CERTIFICATE OF APPROPRIATENESS

**RE: Application Number 21-7194; 1627 (1627-1639) LEVERETTE; Corktown
Historic District**

Project:
Leverette Apartments - Exterior Corrections
Existing Apartment Renovations
Leverette Development, LLC
1627 Leverette Street
Detroit, Michigan 48216

**Front Window
 Corrections**

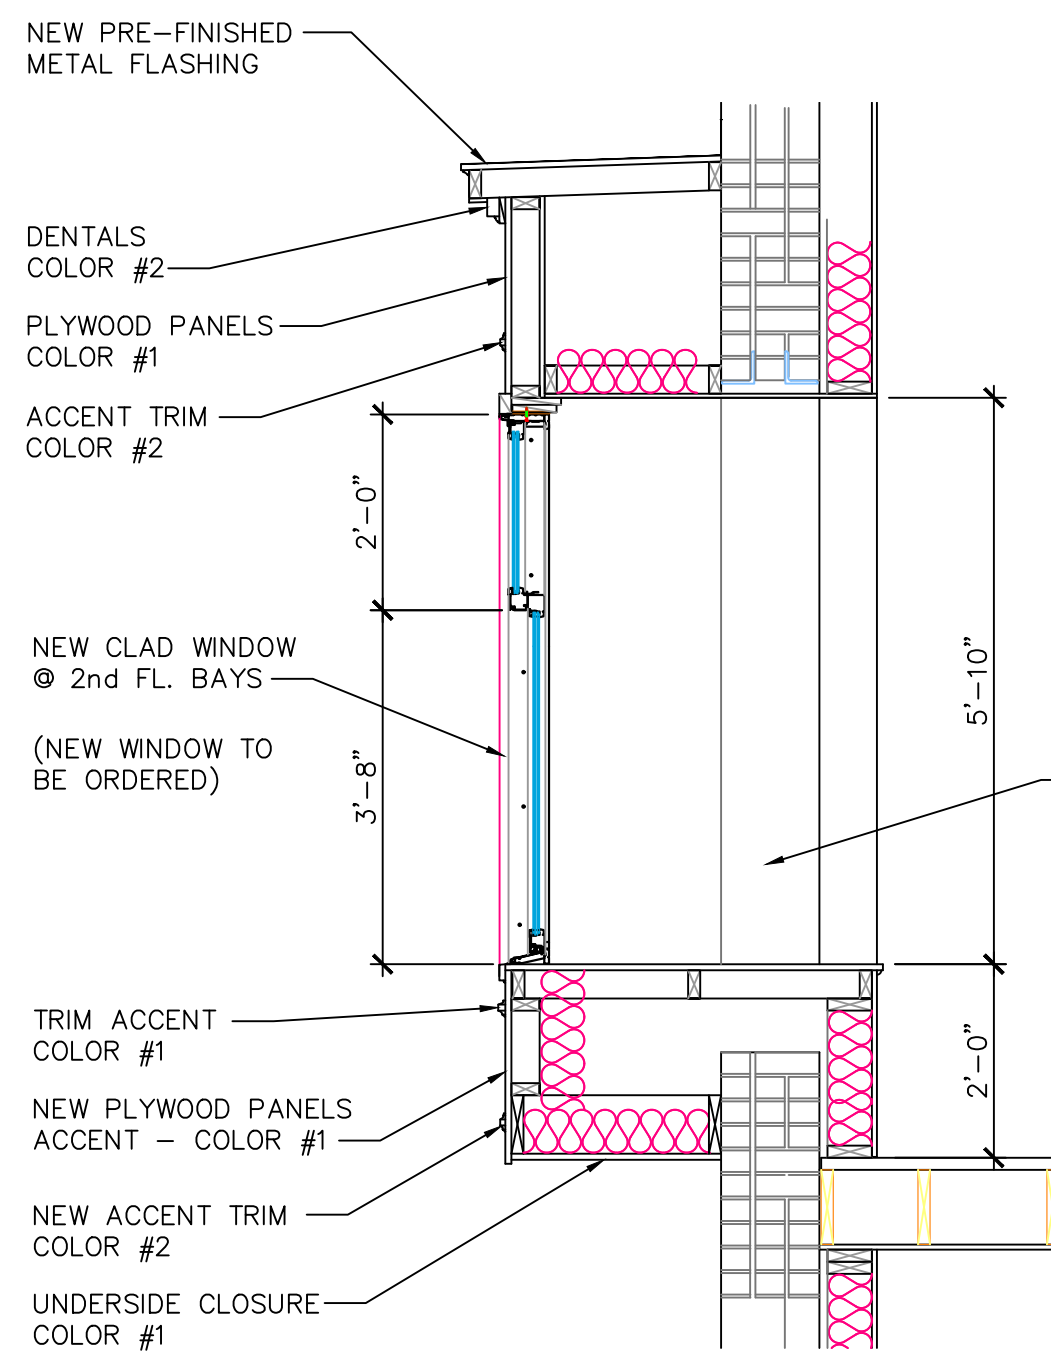
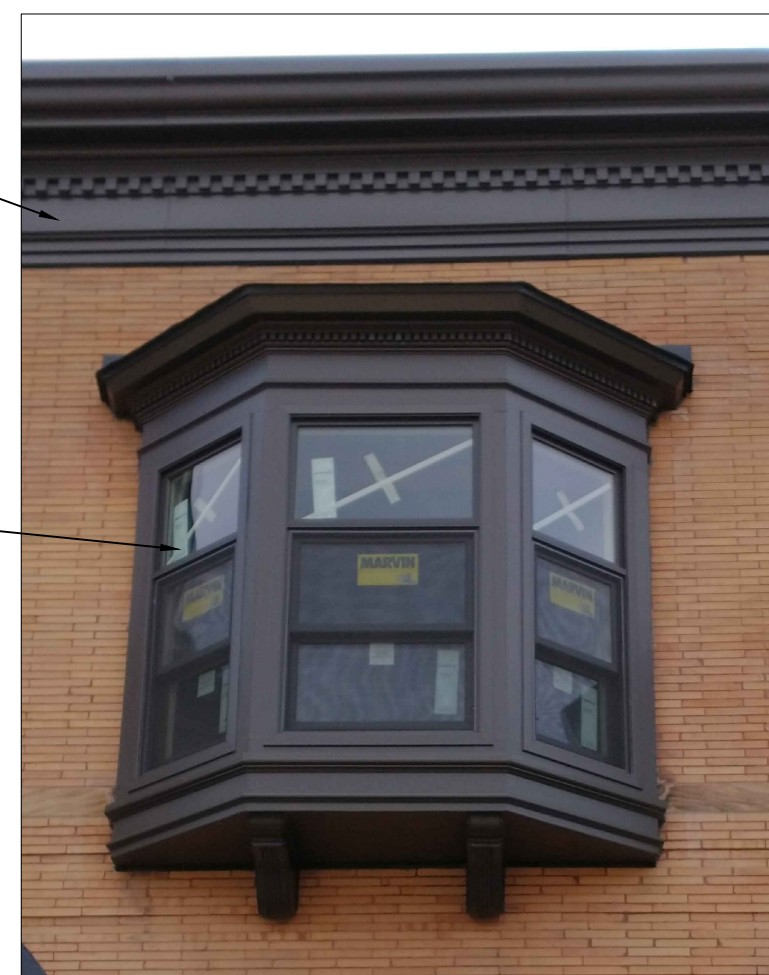
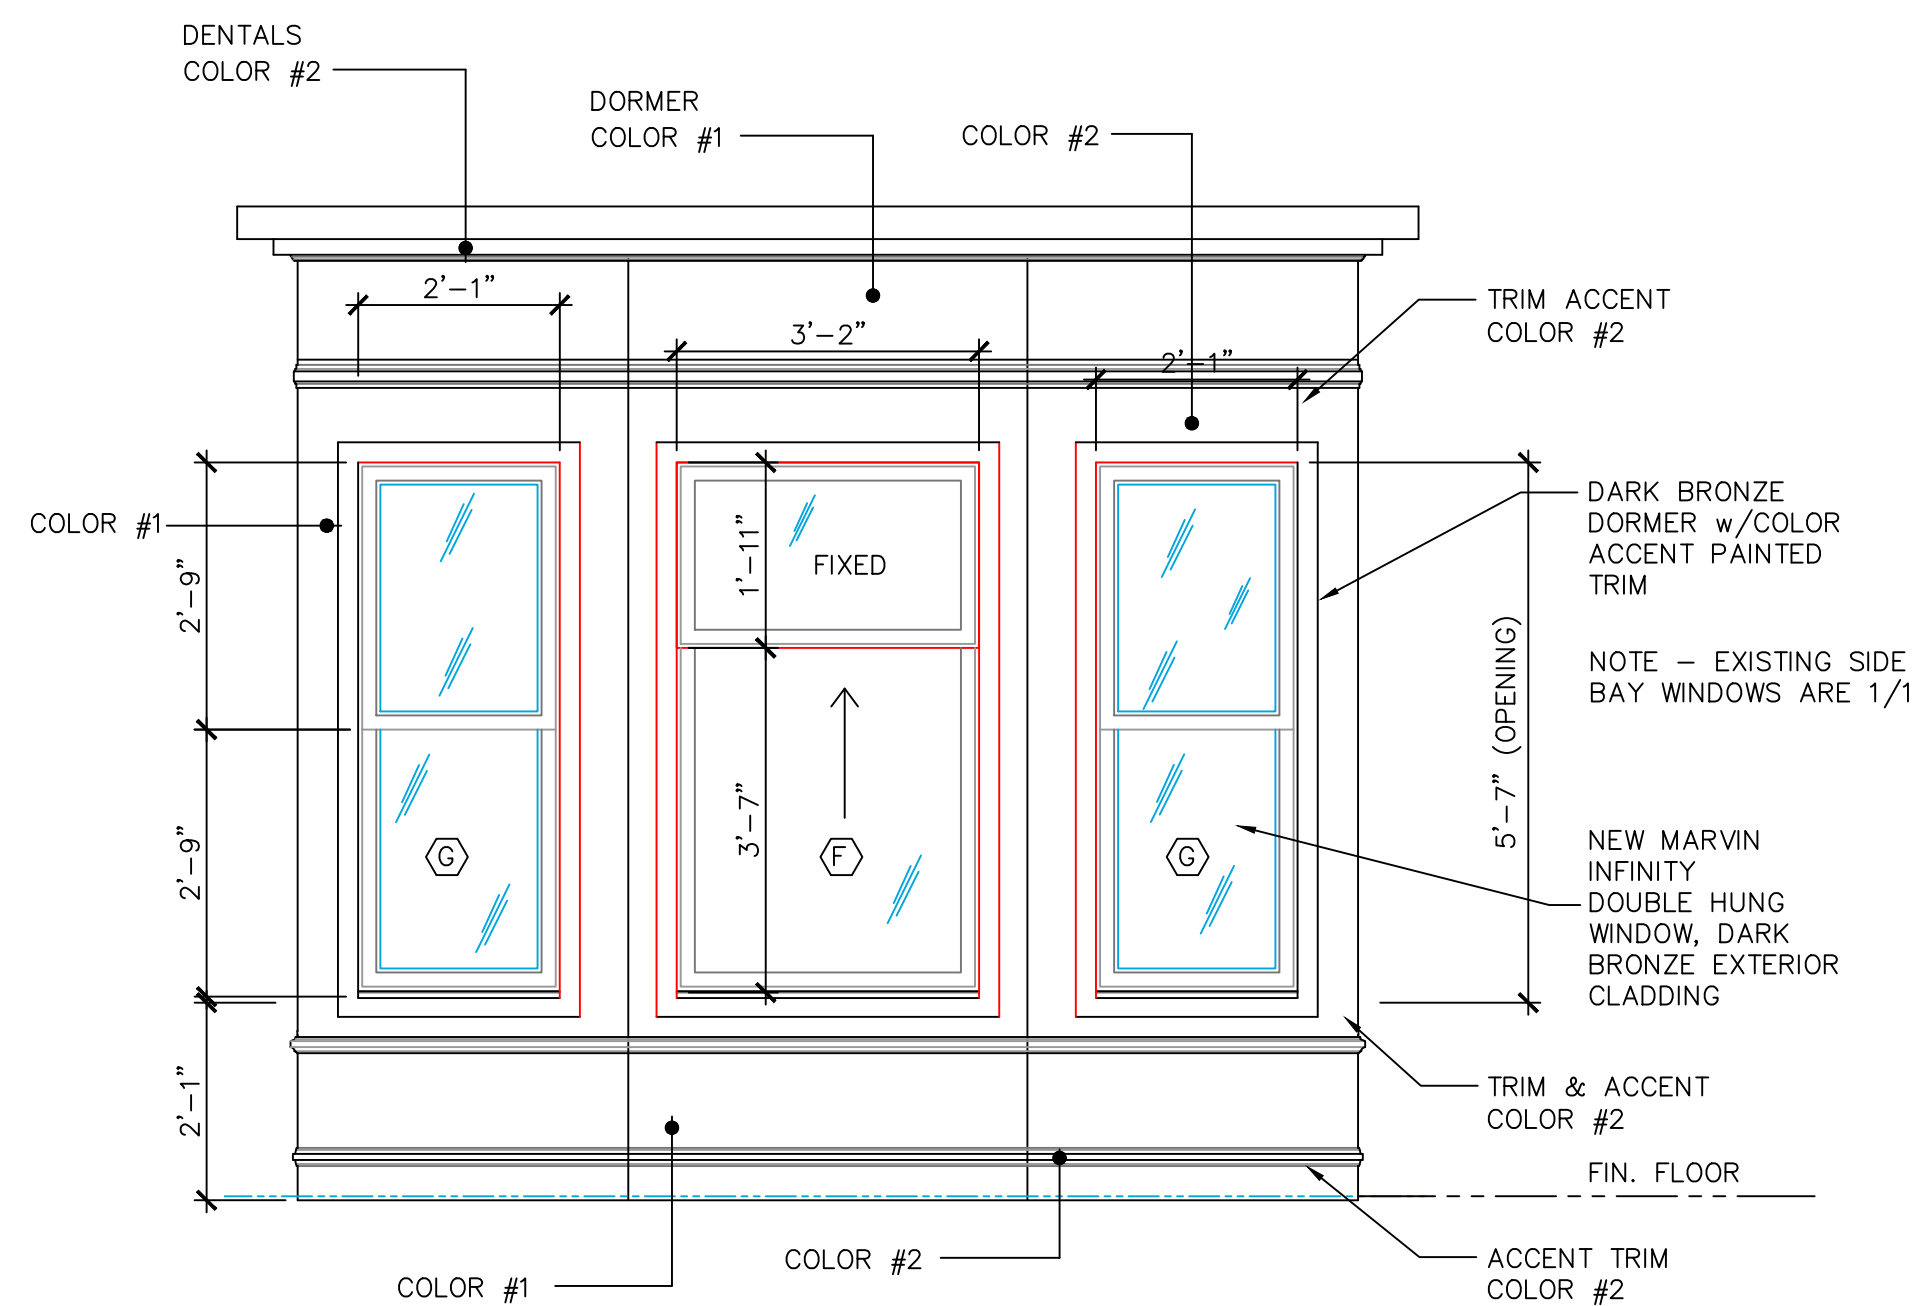
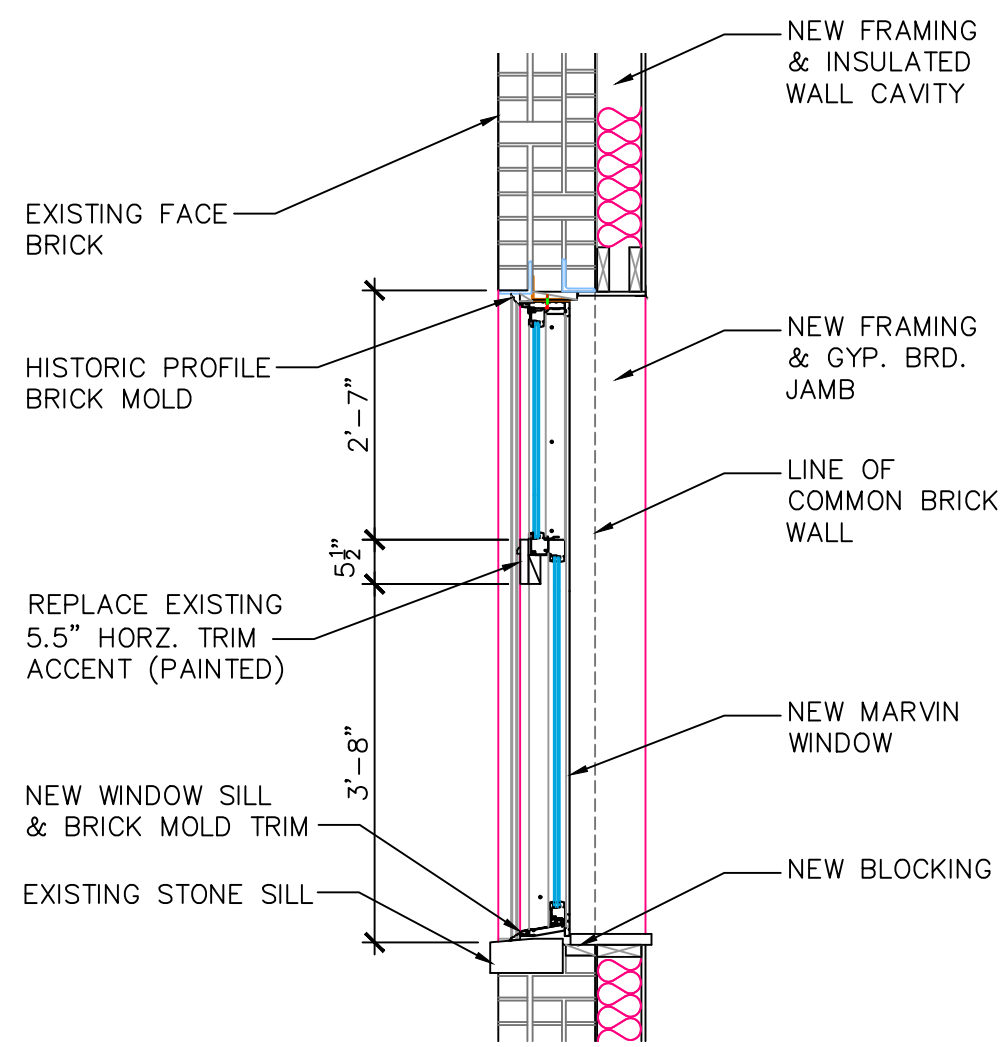
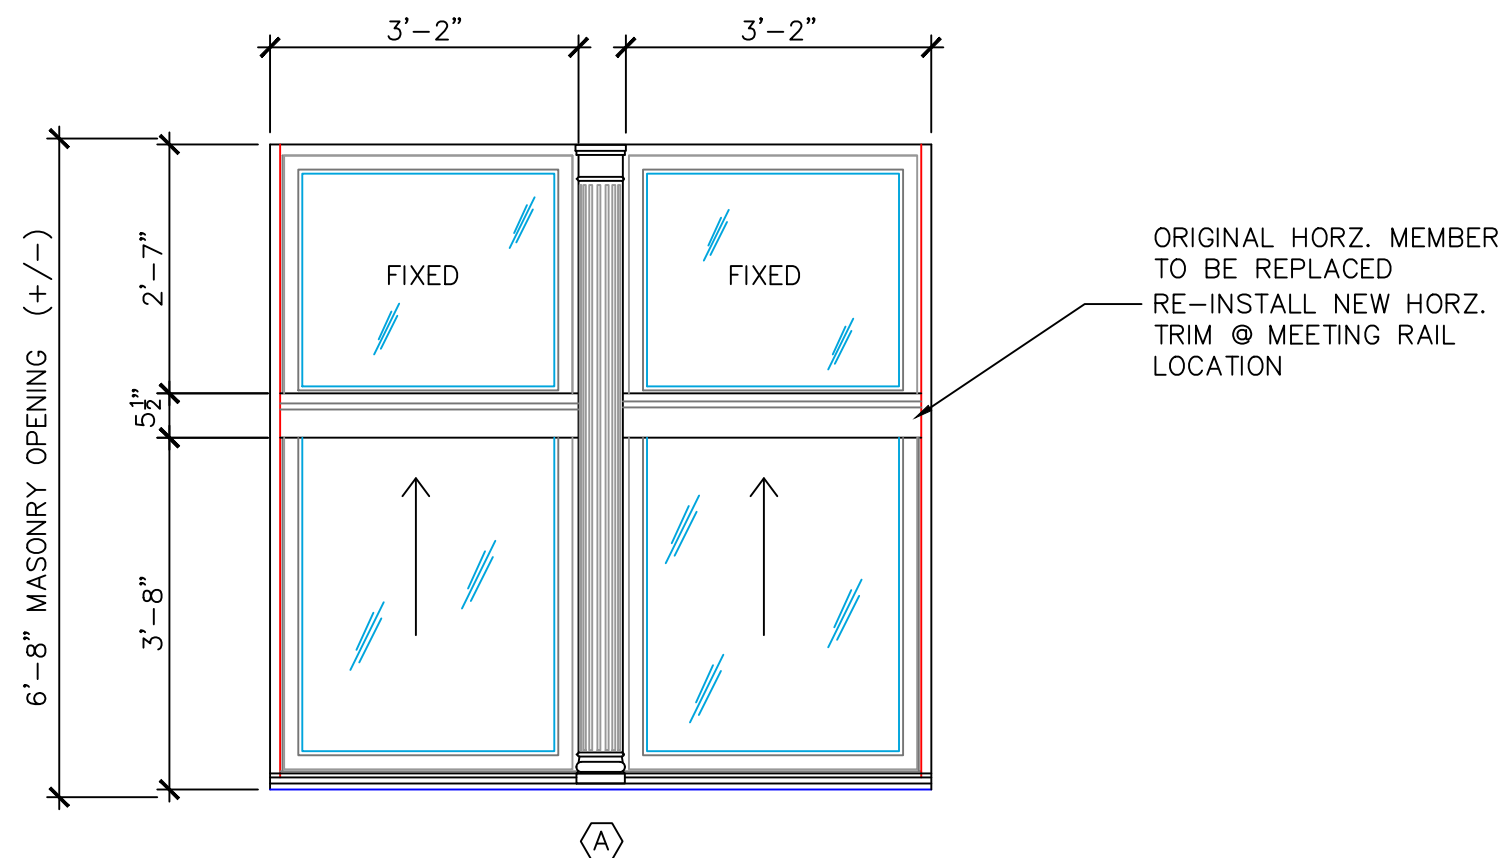
- At front elevation, second story bay windows – original sash were wood, 1/1, double-hung units. In 2020, these windows were replaced with wood, 1/1, double-hung units, each which is topped with a fixed wood transom window without approval. With the current submission, the applicant is proposing to REMOVE all existing windows and replace with new 1/1 aluminum-clad wood units to match the original

- At front elevation, first-story windows – each opening originally included a set of paired fixed wood windows which were topped with fixed wood transom. The sash were set into wood trim. A fluted wood pilaster served as each window opening’s mullion. In 2020, these windows were replaced with 1/1, double-hung, wood-sash units with aluminum-clad trim. The original fluted wood pilaster mullions appear to have been retained. With the current the applicant is proposing to RETAIN the existing aluminum-clad wood windows. However, the new proposal includes the addition of wood trim at each window’s meeting rail to match the original

Please note that the submitted drawings indicated that the new/replacement cornice which was removed without Commission approval in 2018 was to be replicated, down to the “decorative leaf” detailing (ie, the swag detailing). However, the current cornice *does not* include that decorative detailing. With the current submission, the applicant is stating that they intend to apply the decorative leaf and swag detailing to the current cornice

- The swag detailing must be applied to the current RFP cornice so that it replicates the original cornice, as indicated in the submitted drawings and required by the Commission's 2018 COA

PARAPET LEVEL
 INSTALL DECORATIVE LEAF ON CORNICE (EXPECTED DELIVERY FOR DECORATIVE LEAF - MARCH 1, 2021)

SECOND LEVEL
 REMOVE UN-APPROVED BAY WINDOWS & INSTALL NEW WINDOW MATCHING PROPORTIONS OF EXISTING BAY WINDOW OPENINGS; REPAINT TRIM ACCENT (COLOR #2) (BASE COLOR TO REMAIN THE SAME)

FIRST LEVEL
 RE-INSTALL HORIZONTAL TRIM MEMBER AT MEETING RAIL - (RE-INSTALL HORIZONTAL TRIM AT LOCATION OF REMOVED WINDOW HORZ. MEMBER)
 APPLY NEW TRIM COLOR ACCENT AS INDICATED ON PICTURE OF ENTRY
